Introducing

METAL-FAB

B-Vent Locking System

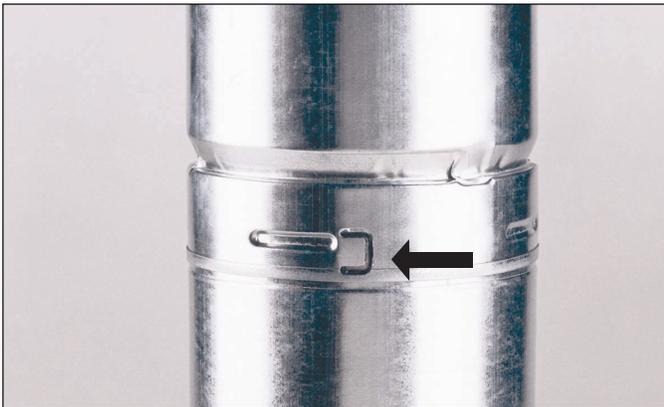
1. The design of the SureLock™ locking system is unique. The male end of the pipe features a square dimple, positioned in the exact location to match the tab that is located on the female end of the pipe. When the pipe is joined and twisted until it stops, the SureLock™ tab can be pushed into the square dimple, therefore creating a positive lock that cannot be twisted apart. So unique that a patent is pending.

2. The SureLock™ locking system will be a running production change in 3"-6" diameter pipe sections.
3. Your current inventory is not obsolete. The SureLock™ pipe connects with regular Metal-Fab B-Vent and "twist locks" just as before.
